**POTENTIAL IMPACTS OF GOLD MINING IN THE RAGGED TOP
AREA ON SPEARFISH CANYON, SOUTH DAKOTA**

**Prepared for
Spearfish Canyon Owners Association**

Nuri Uzunlar, PhD

August 28, 2020

Figure 10. Topographic map of the area showing groundwater monitoring wells and proposed mining pit (from VMC permit application)

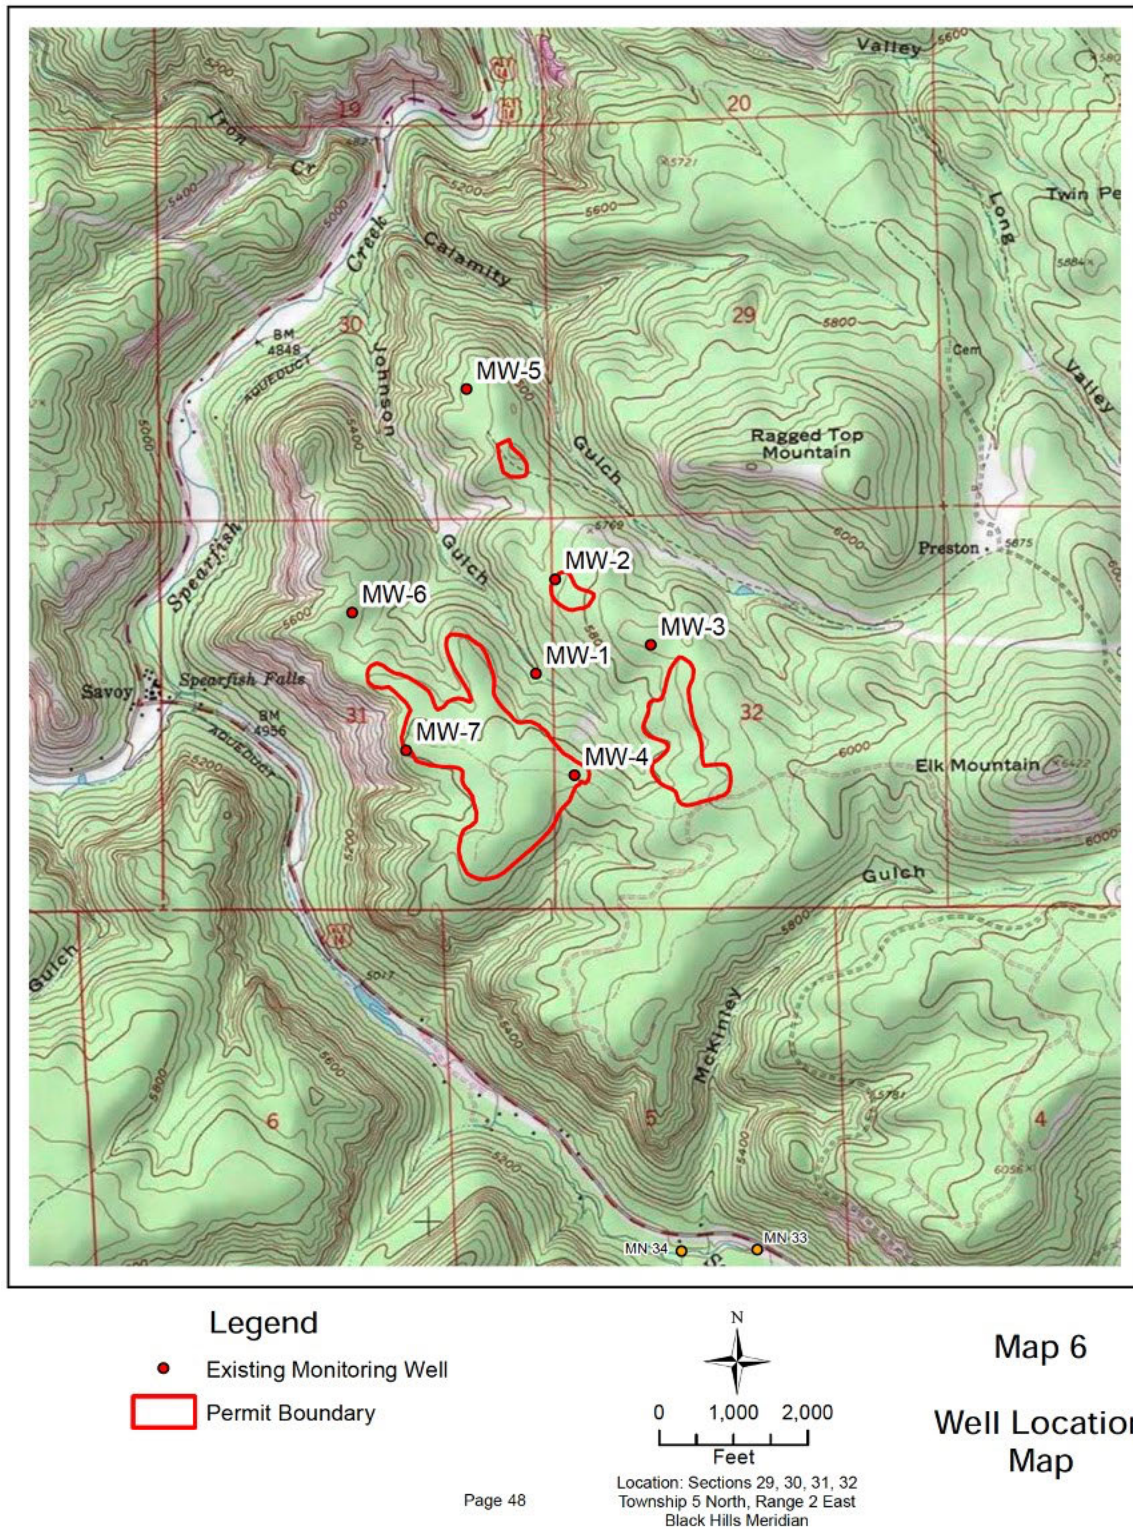
VMC LLC maintains a network of surface water and groundwater quality monitoring stations associated with the project and has collected baseline water quality data for surface water and groundwater. Seven groundwater monitoring wells are present in the vicinity of the project area (Figure 10).

Based on data collected from monitoring wells within the permit area, the water table is about 450-500 feet below the surface (company officials oral communications, August 2020).

Therefore, Pahasapa Limestone is not considered an aquifer in the Ragged Top district.

Figure 15. Proposed permit area (Figure modified from VMC permit application), showing vantage points and currently operation Wharf mine. The yellow box is about 100 acres. Total disturbed area including roads and prep sites could easily exceed 200 acres.

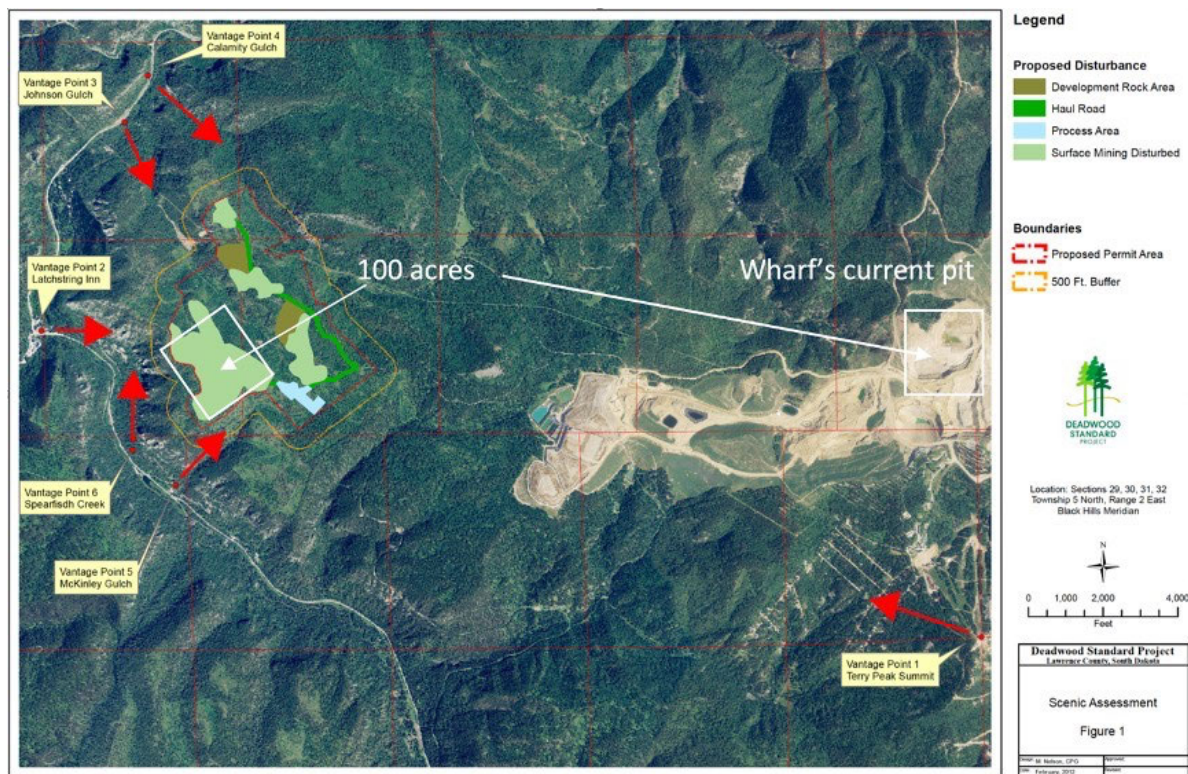
The original Homestake Mining Company Permit 416 proposes mining ore in more than 120 acres. Valentine Mining Company submitted a modified version of the permit 416 in 2012 proposing mining in a total area more than 170 acres. This translates to 200 plus acres of disturbance considering 20% buffer zone around the proposed pit limits. Figures 12 and 13 show the area of interest, including the buffer zone, is clearly bigger than 500 acres. Request to see mine plans and related ore deposit model was declined by company officials, therefore we have to make some calculated assumptions. Assuming total disturbed area is 200 acres as pointed out in the caption of figure 12.

The area receives more than 25 inches of rain annually, highest in the Black Hills. If the mine reaches to full capacity in short period of time removed and stockpiled soil and waste rock could be subject to rapid erosion which subsequently create large amounts of sediment transport to Spearfish Creek from Johnson Gulch and Calamity Gulch.

Thirty feet of overburden will require drilling and blasting. This would result in more than 10 million tons of stockpiled rock if it's done across 100 acres. If the mine reaches to full capacity in short period of time removed and stockpiled soil and waste rock could be subject to rapid erosion which subsequently create large amounts of sediment transport to Spearfish Creek mainly from Calamity Gulch and possibly from McKinley Gulch.
